## ADDENDUM #1

Reference: Student Services Remodel – Davis ATC Campus  
Utah College of Applied Technology – Kaysville, Utah  
DFCM Project No. 06134220

**Addendum No. 01**

Project: Student Services Remodel  
Address: Davis Applied Technology College  
City, State: Kaysville, Utah  
Owner: DFCM, State of Utah

**B4** DETAIL @ SKYLIGHT  
 3" = 1'-0"

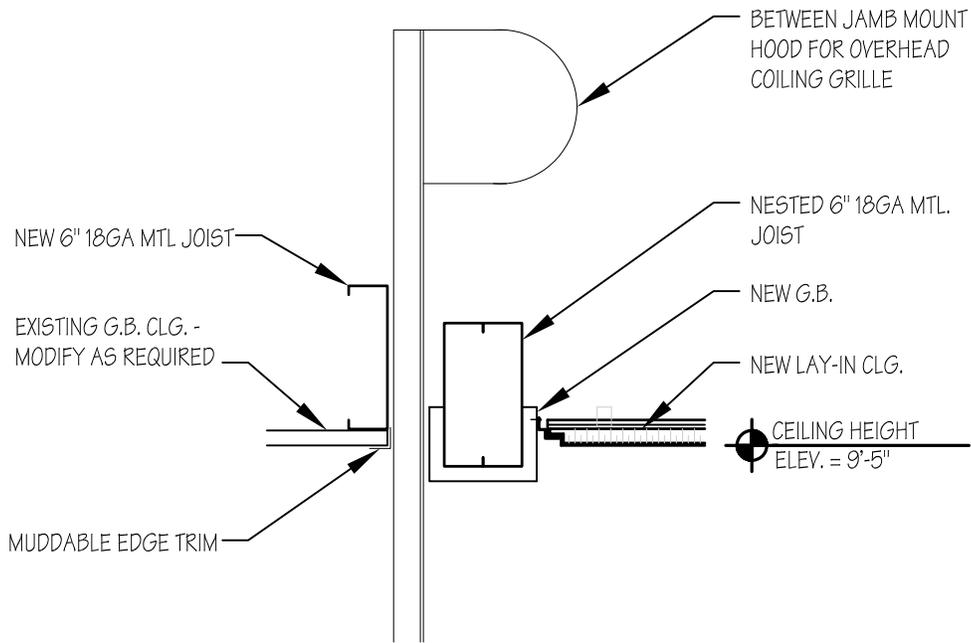
- 1-5 AE111 **Reflected Ceiling Plan**  
 At the skylight well at approximately grids 6 & E, provide an additional 6" metal stud and gypsum board drop per the attached detail B4/A501, and paint the entire skylight well (protect the existing fabric shade at the top of the light well).

**A3** OVERHEAD COILING GRILLE DETAIL  
 1-1/2"=1'-0"

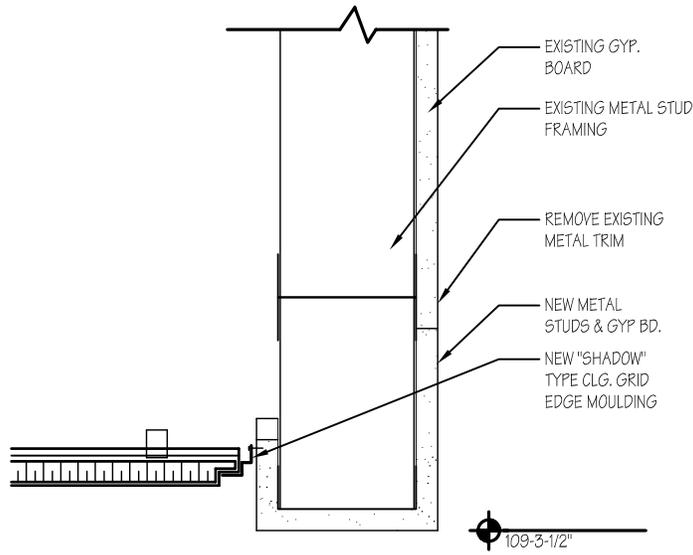
- 1-6 AE602 **Detail A3/AE602**  
 Replace with new detail included with this addendum
- 1-7 E2.11  
 Tie the new overhead coiling grille opener to a 120V 20 Amp Emergency Circuit. Field verify and coordinate with the DATC Facilities Manager for the exact location of the Emergency panel. Also tie the roll up door opener to the fire alarm control panel so that when the fire alarm system is activated, the roll up grille shall open. Coordinate with the grille supplier and provide all necessary hardware for a complete installation.
